Subject: SQUEAK NOISE FROM RIGHT FRONT DRIVESHAFT (SKYACTIV 6AT ONLY)	Bulletin No.: 03-001/19
	Last Issued: 03/22/2019

2012-2013 Mazda3 (SKYACTIV A/T only)

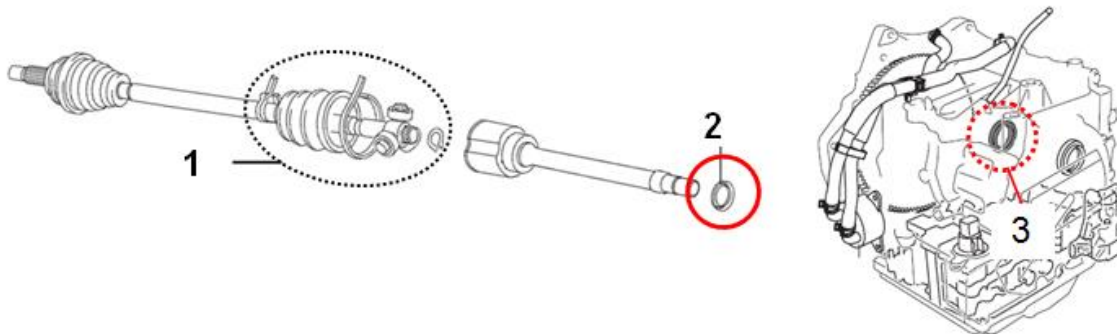
Some vehicles may exhibit a squeak noise from the right front driveshaft at the automatic transaxle when driving. This concern is likely to occur when driving at speeds between 37-50 mph (60-80 km/h) with the ATF at normal operating temperature. The noise is caused by stick/slip between the oil seal at the transaxle and the dust cover of the driveshaft. To correct this issue, the thickness of the dust cover has been increased.

1. Verify concern
2. Replace the dust cover and the converter housing side oil seal with modified ones according to the instructions on MGSS (FRONT DRIVE SHAFT REMOVAL/INSTALLATION), FRONT DRIVE SHAFT (TRIPOD JOINT) DISASSEMBLY/ASSEMBLY and (OIL SEAL (DIFFERENTIAL) REPLACEMENT Converter Housing Side).

1	Inner joint boot set
2	Dust cover
3	Oil Seal
